Application No. FDEC-R4-143 November 14, 2022

Application for approval to amend the Implementation Plan for Fukushima Daiichi Nuclear Power Station as Specified Nuclear Facility

The following amendments are made to the changes in operation structure of the ALPS treated water dilution/discharge facility and selection of nuclides subject to measurement and assessment in order to confirm before discharging ALPS treated water into the sea.

Figure I-1 Flowchart for selection of nuclides to be measured and assessed for discharge of ALPS treated water into the sea

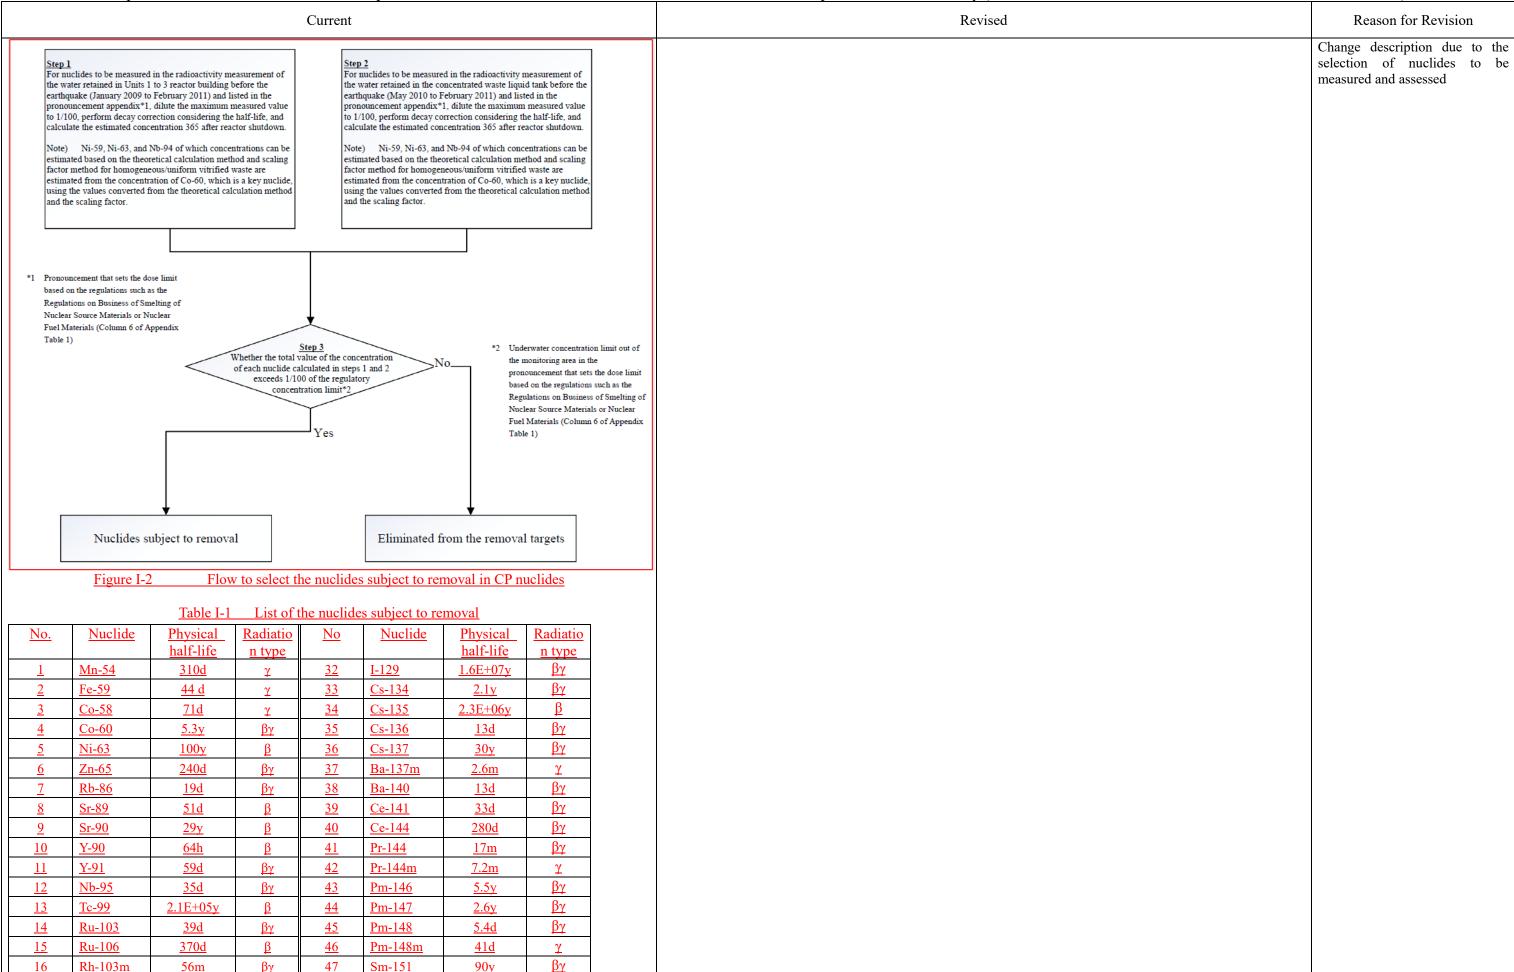
As a result of the selection process according to the above flowchart, the following 30 nuclides were selected. Before discharging ALPS treated water into the sea, it will be confirmed that the nuclides selected for measurement and assessment based on the flowchart in Figure I-1 satisfy the discharge criteria (sum of the ratios to regulatory concentration limit of nuclides other than tritium is less than 1.)

These nuclides to be measured and assessed are selected based on the results of past analyses. However, there is a possibility that the situation may change depending on the progress of the decommissioning work in the future. Therefore, the following methods are used to confirm that there are no significant nuclides other than the selected nuclides to be measured and assessed (hereinafter "other nuclides"). If it is confirmed that other nuclides are significantly present during this confirmation process, re-assessment of the nuclides to be measured and assessed will be performed. The decay of radionuclides will be also reflected in the selection flowchart.

Figure C-1 Flow of setting of previous management values

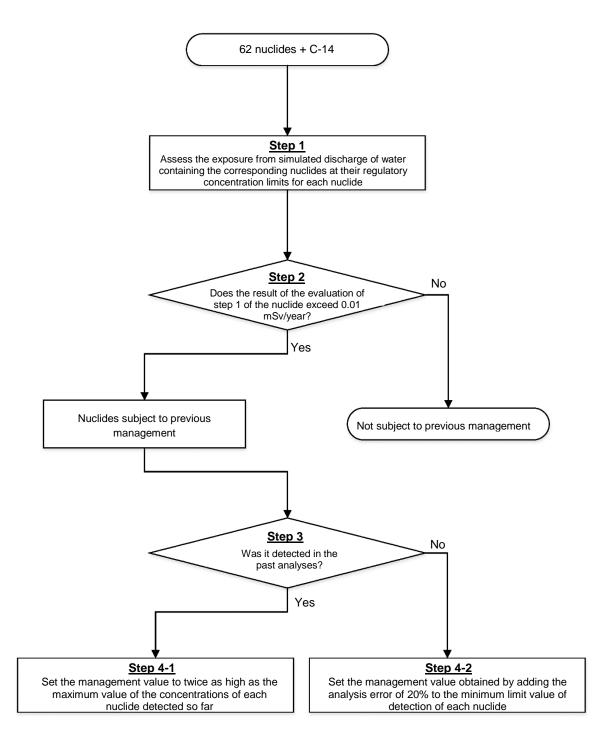
Figure C-1 and Table C-6 show the setting flow of previous management values and the set previous management values, respectively.

Appropriate description due to the selection of nuclides to be measured and assessed
